<p align="center"><b>PNG WEST 2018-2019 REVENUE REQUIREMENTS</b> <b>EXHIBIT A-9</b></p>
---

**Re: Pacific Northern Gas Ltd. – 2018-2019 Revenue Requirements Application – Project Number 1598935 – Information Request No. 2**

**INFORMATION REQUEST NO. 2 TO PNG**

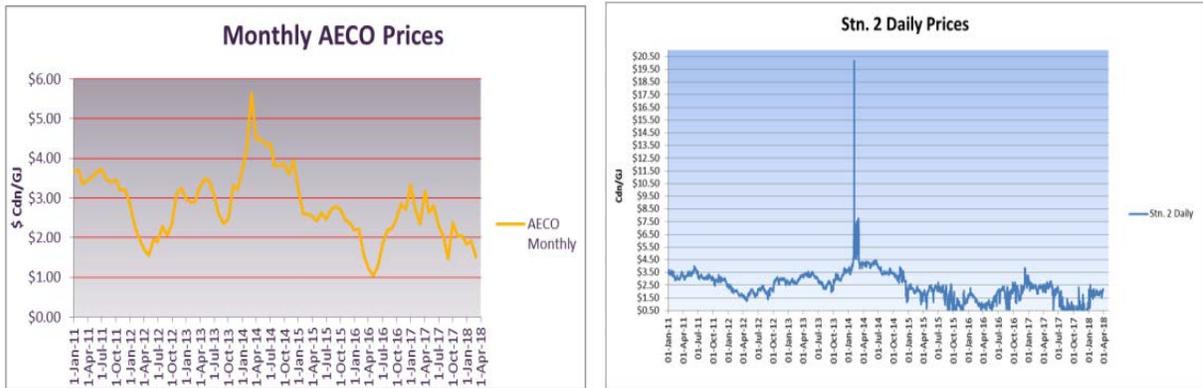
- 92.1 Please provide a working excel model with the NPV Analysis provided in Appendix A3.
- 92.2 Please provide a justification for the selected 10 percent depreciation rates for the GIS project capital costs.

- 92.5 The NPV Analysis included in Appendix A3 does not include any operating cost reductions related to the GIS Project. Please discuss if there are any expected reductions in operating and maintenance costs or any other quantifiable financial benefits associated with the GIS Project that should be included in the NPV analysis. If so, please quantify by category and provide a revised NPV analysis.
